**PLANNING & ZONING**  
**February 06, 2025**  
**5:30 PM**  
**City Hall**

### **MILLS CITY PLANNING COMMISSION**

## **Lots 2A & 3A, Sage Addition**

**Vinich Development  
Commercial Development Plan**

# PRELIMINARY SITE PLAN FOR VISION BEYOND BORDERS IN THE CITY OF MILLS NATRONA COUNTY, WYOMING

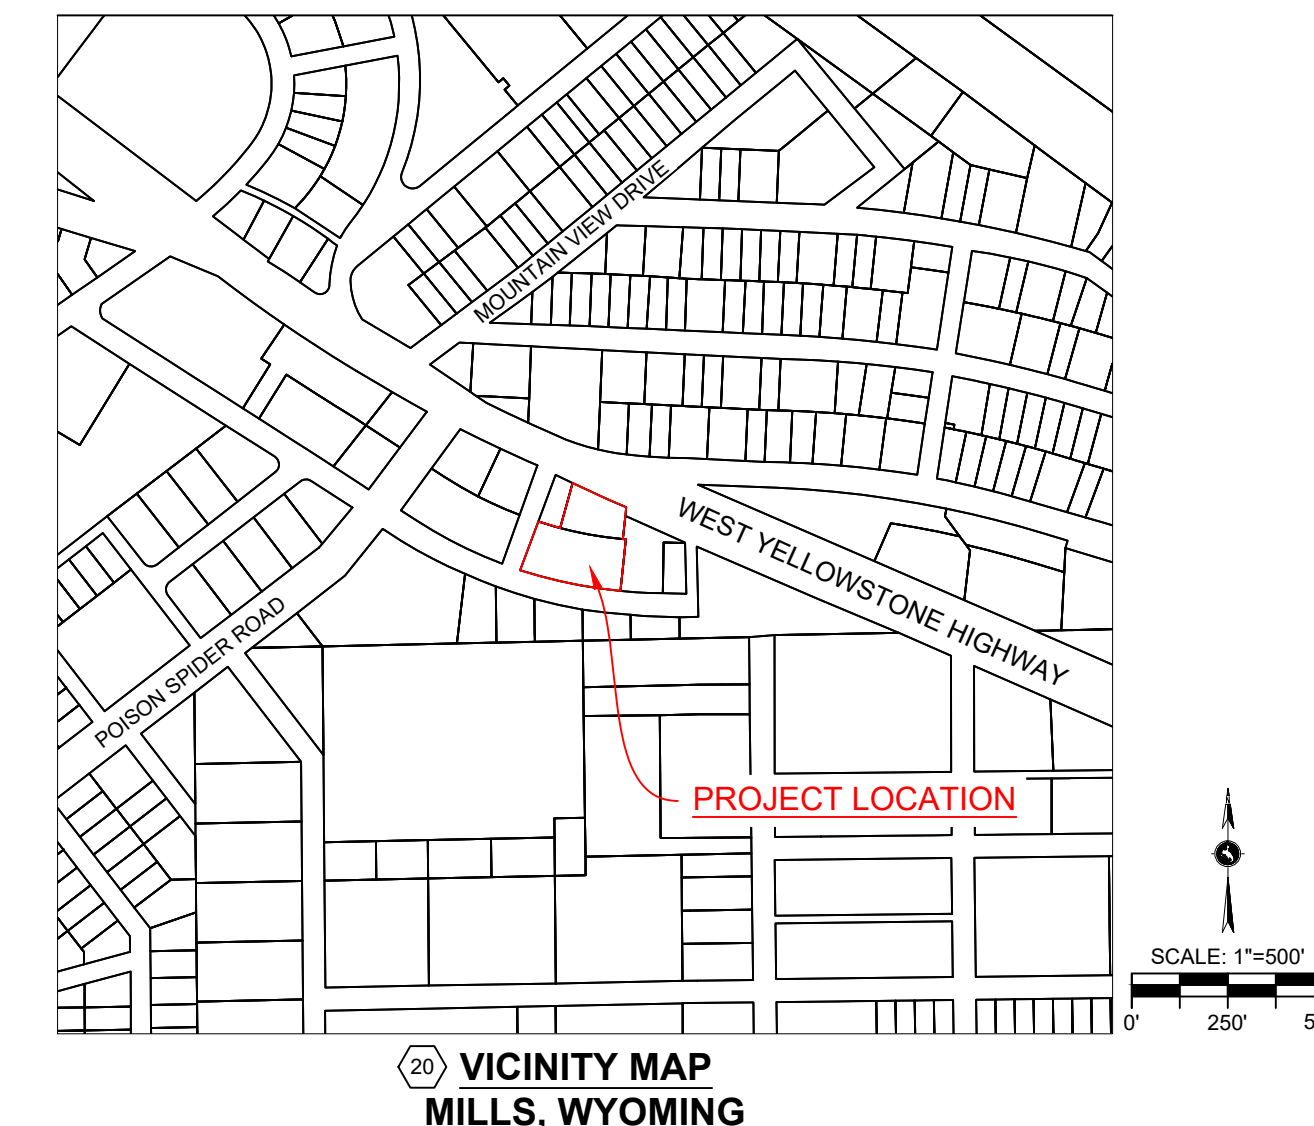
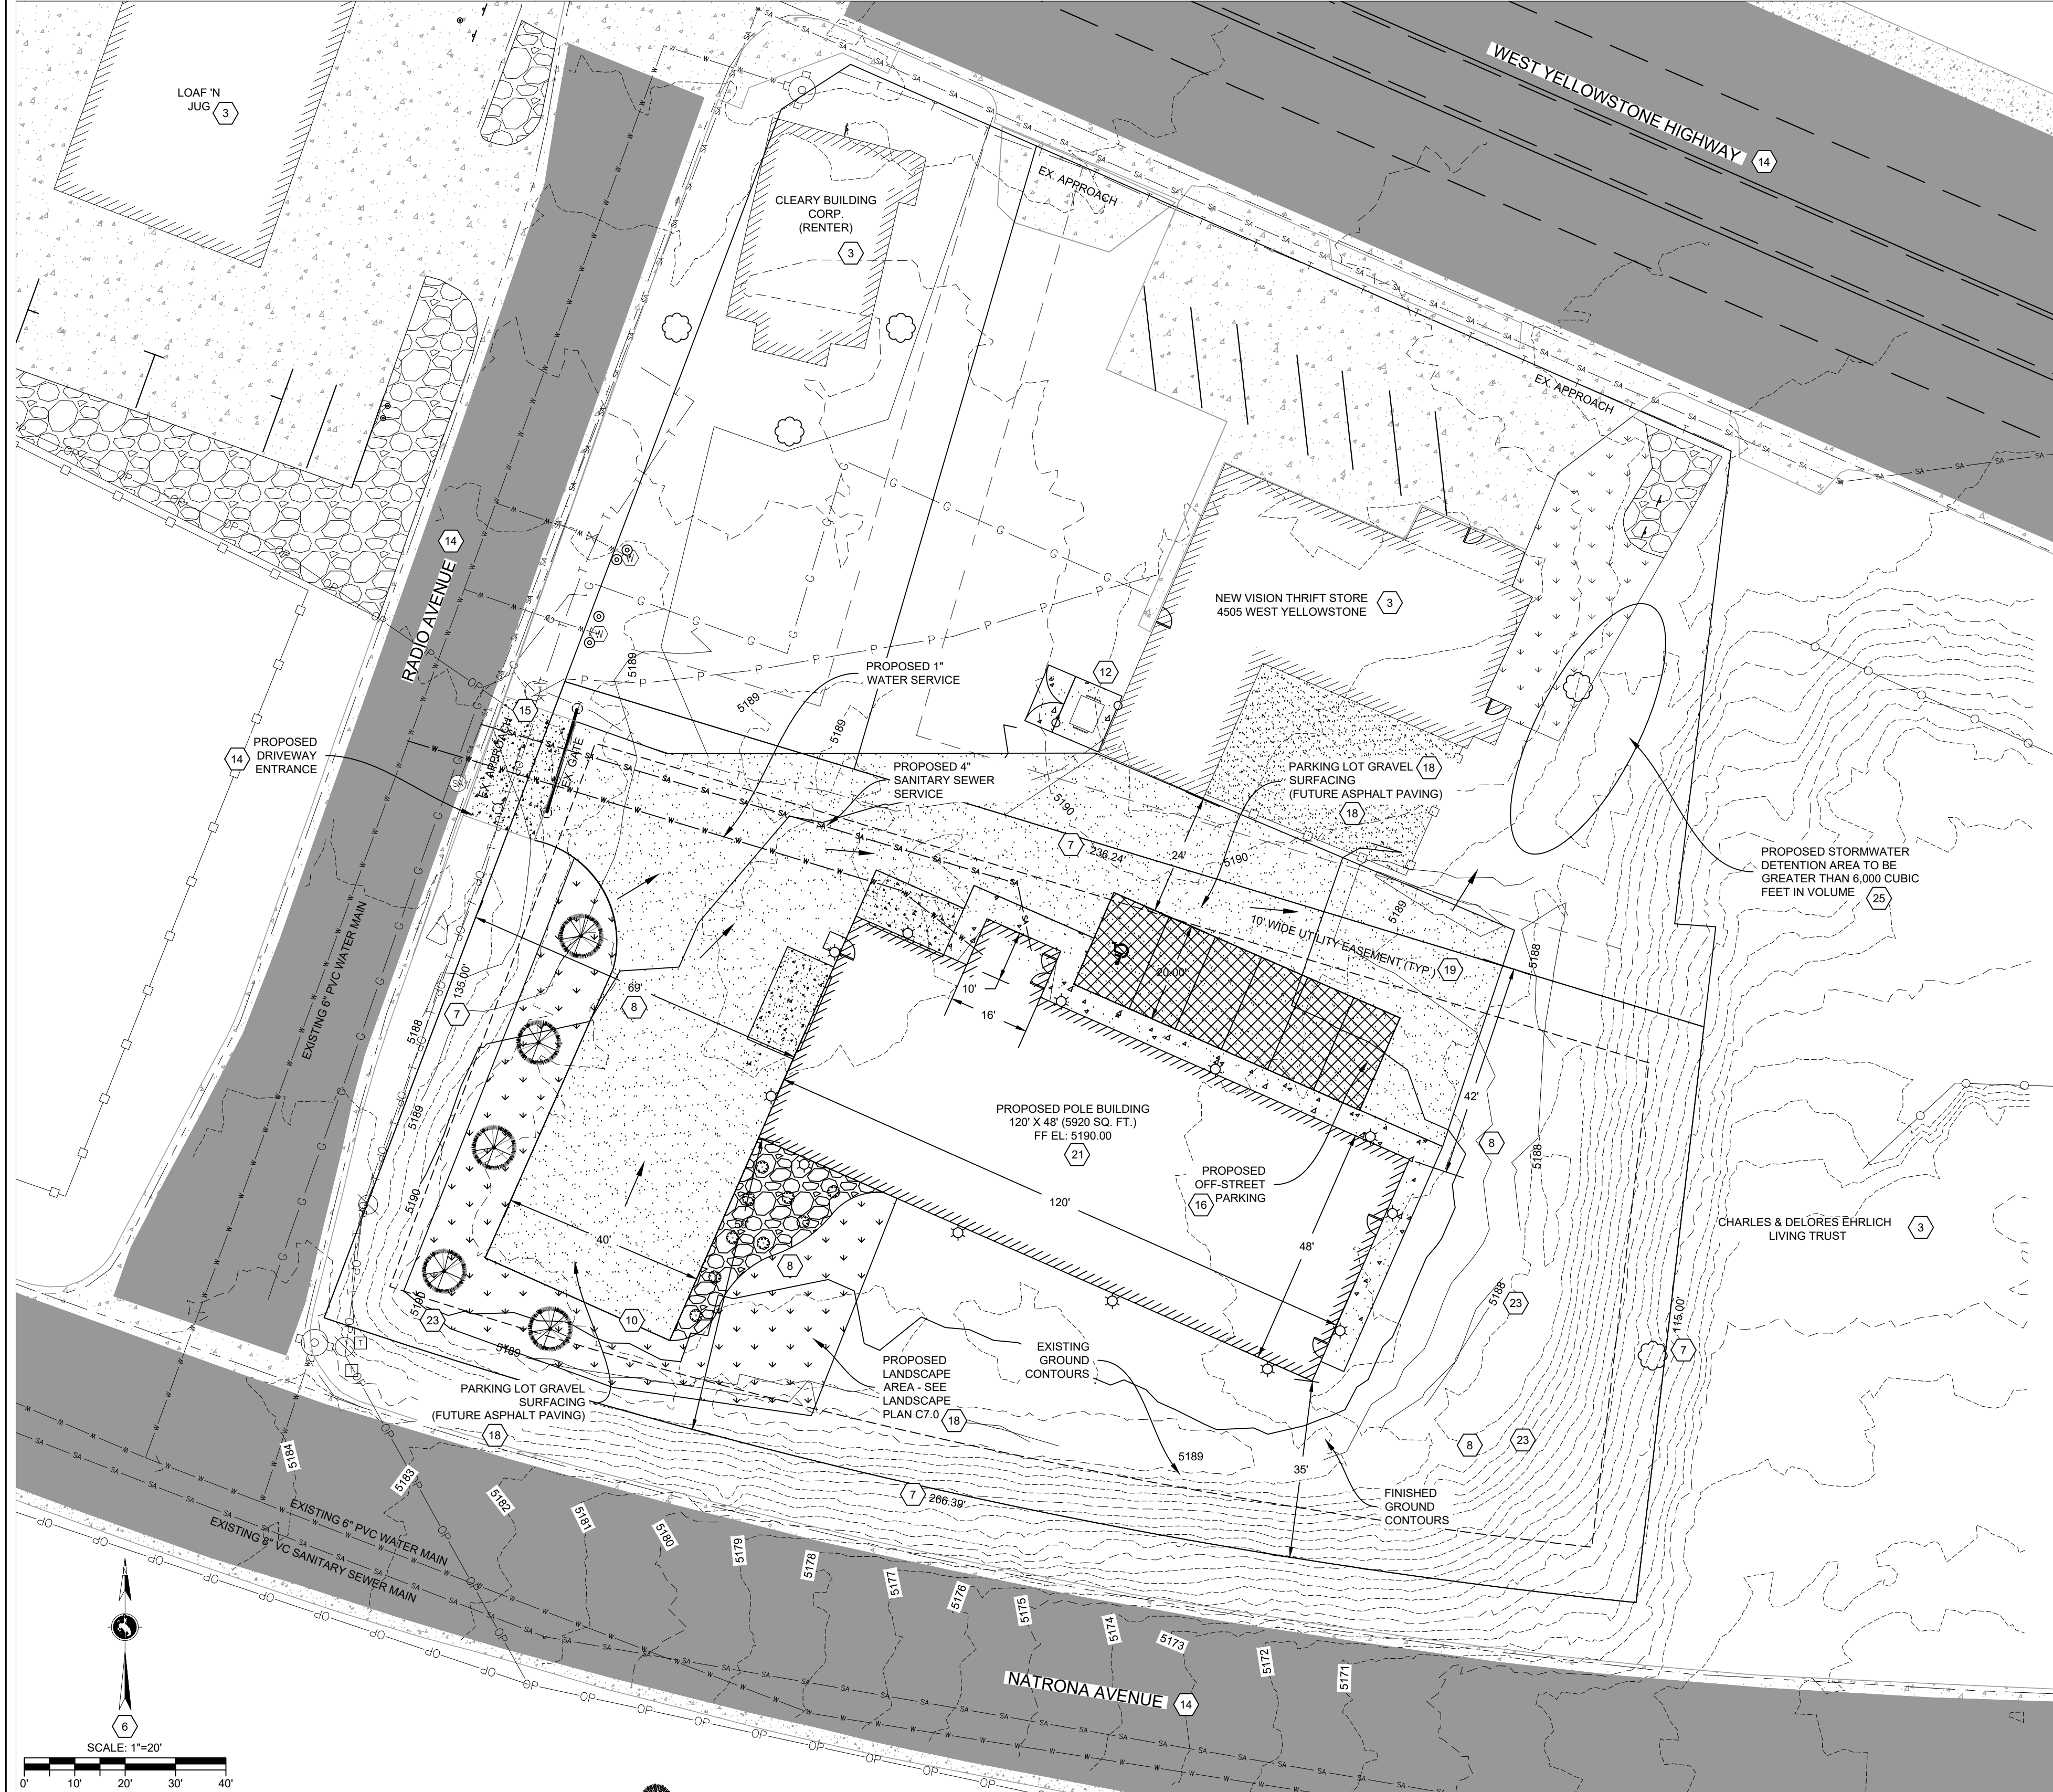
The submitted Development Plan depicts the required six (6) parking spaces as paved, however, the applicant has indicated on the Development Plan and in the application their intention to utilize gravel surfacing across the remainder of the site, with plans to pave in the future. The Commission should evaluate this request and either include a recommendation to Council to allow an exception to the paving requirement or request a revision of the application to show a fully paved surface at time of construction.

- a. If the Planning Commission desires to allow an alternate surfacing type, either temporarily or permanently, the motion and recommendation to Council should include language to that effect.

Staff recommends APPROVAL of the Development Plan if all requirements of the LDRs are met, including paving of all entrances, exits and required parking area and all other planning considerations are completed and met.

# LANDSCAPE PLAN FOR

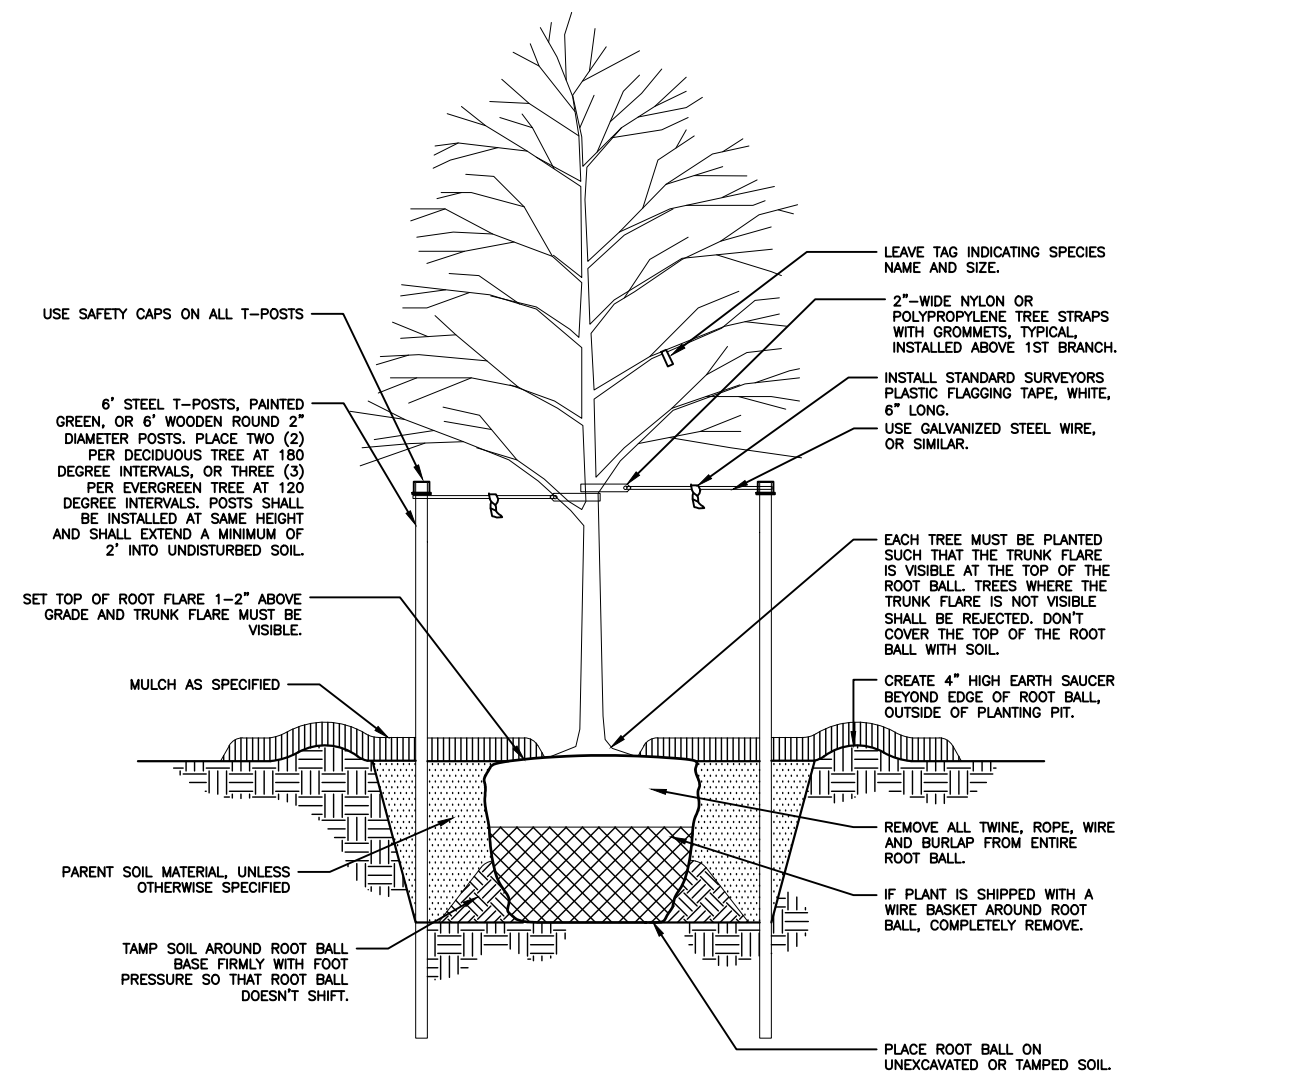
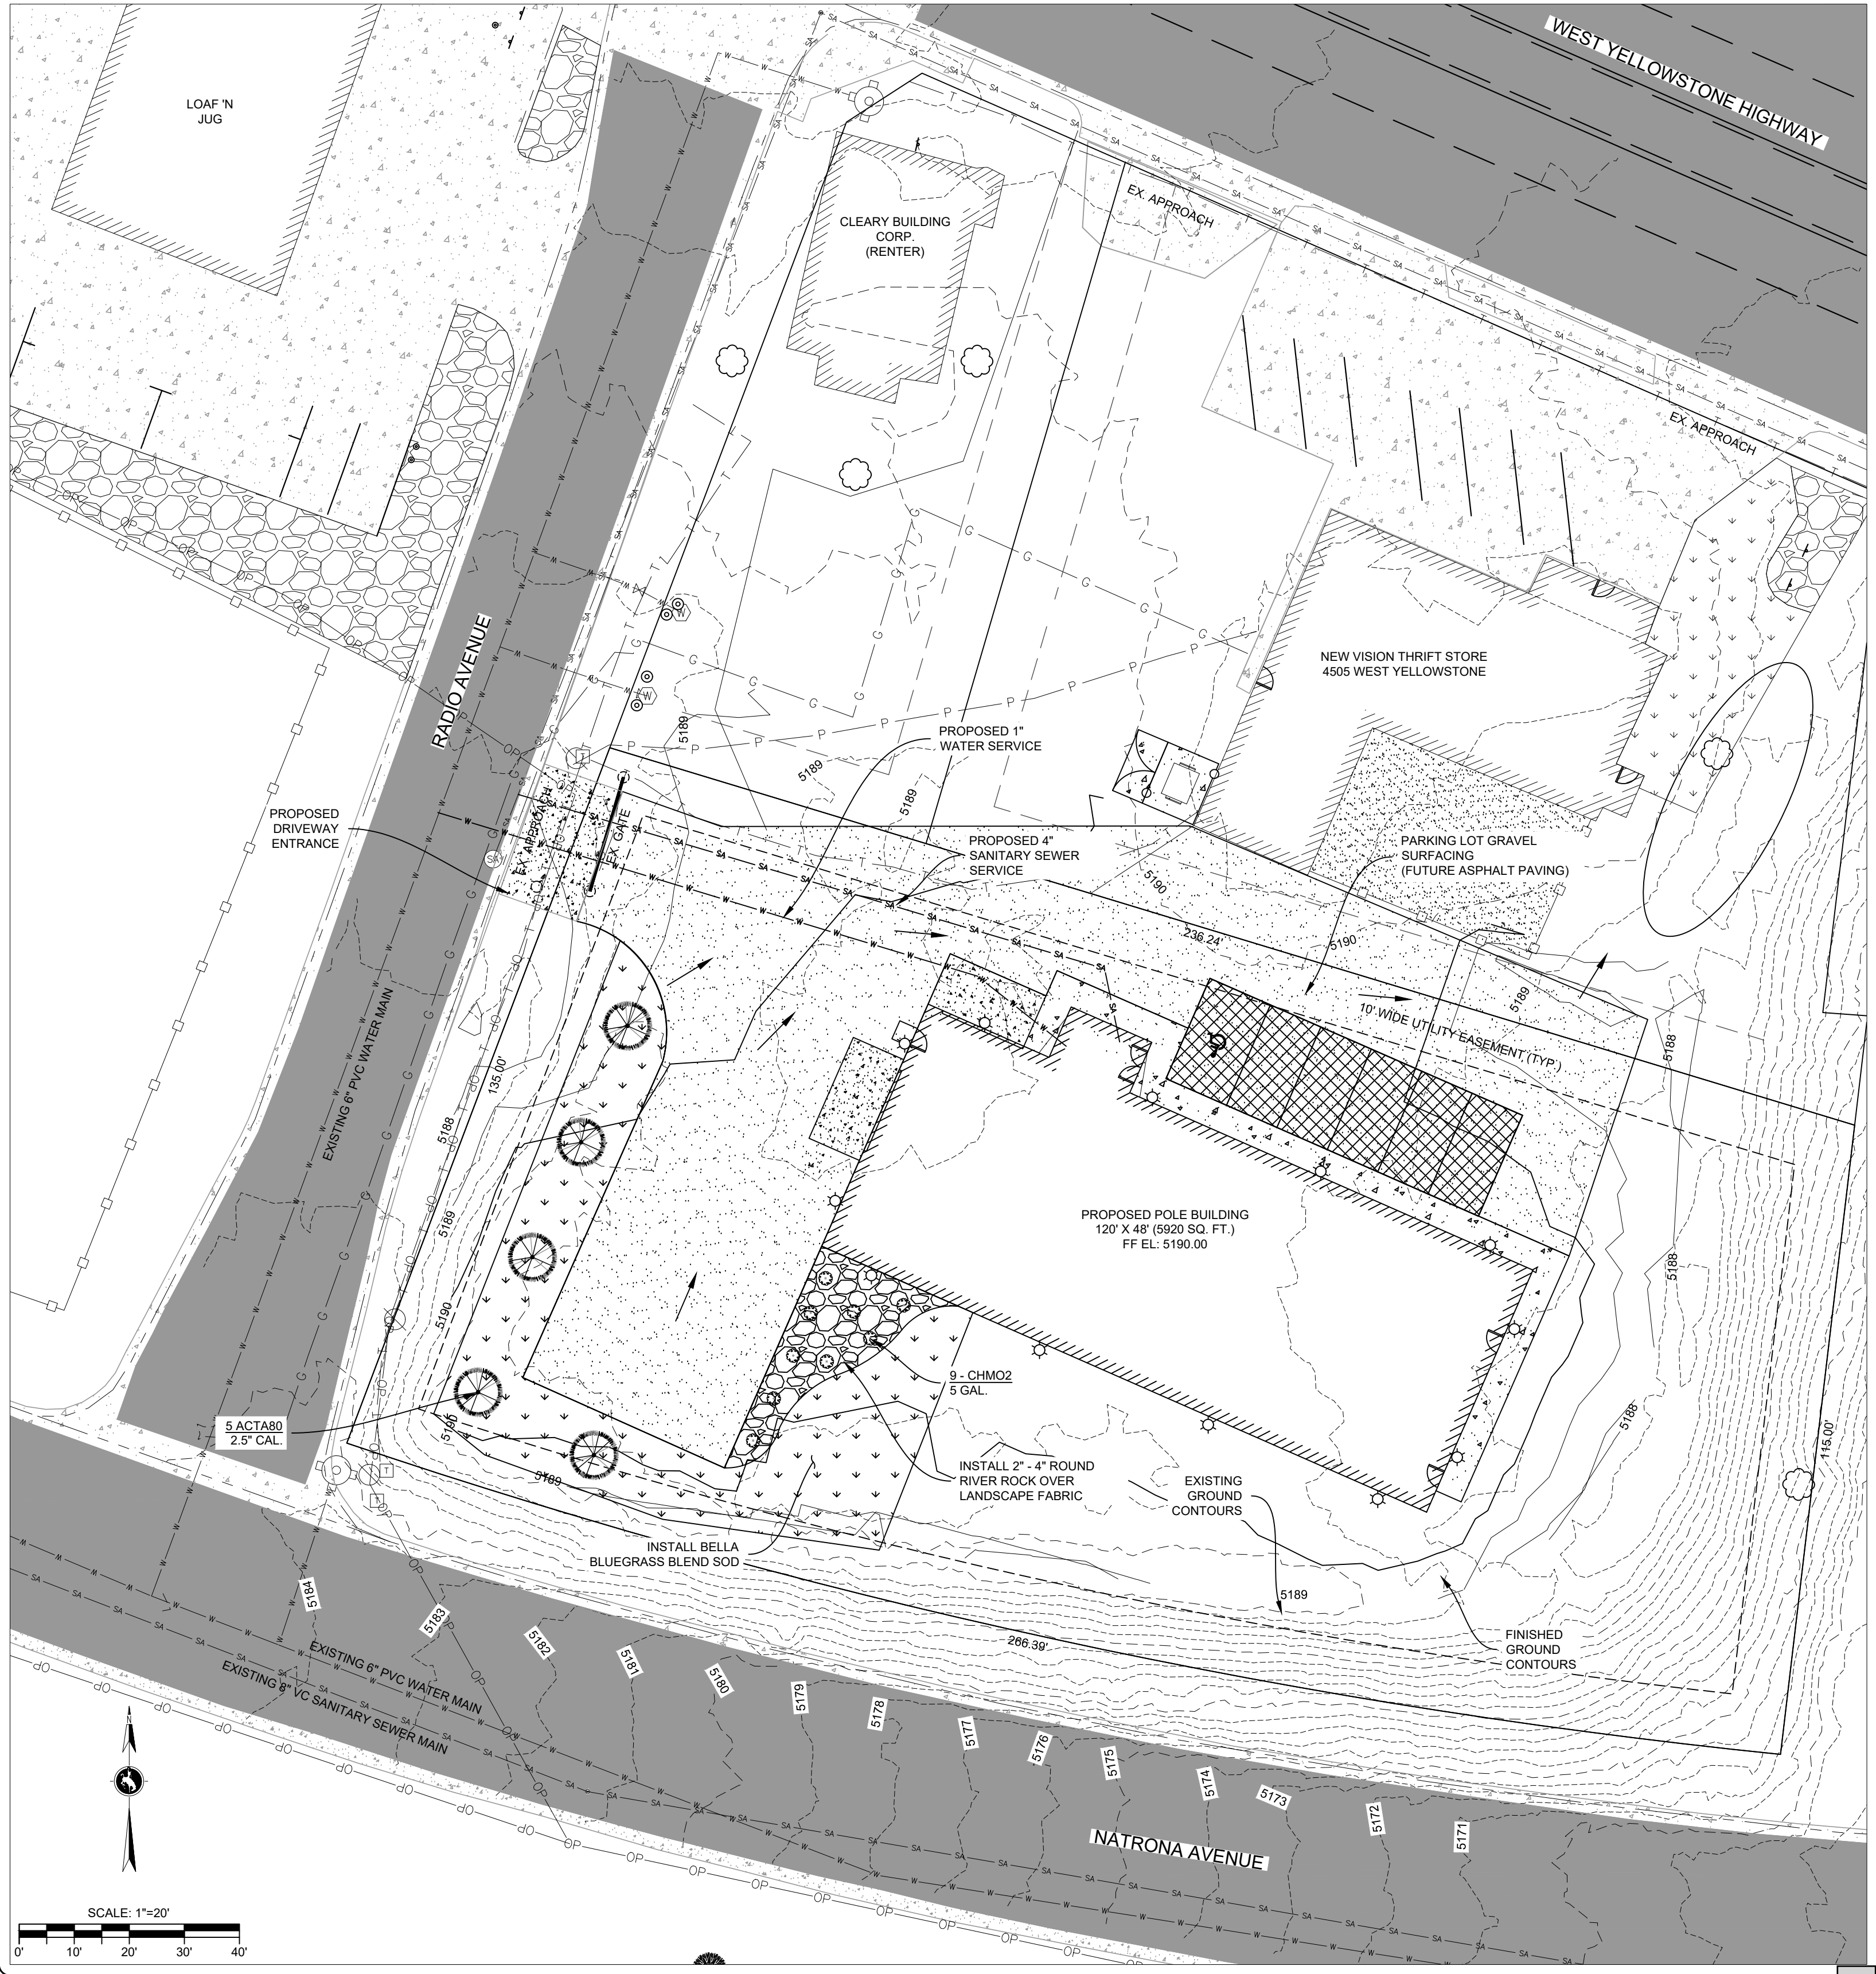
2. Section 40.40(4), a minimum of 10% of the site shall be landscaped. A conceptual landscaping plan was submitted with the previous application. An updated, detailed landscape plan has been submitted and appears to be in conformance with the LDRs.
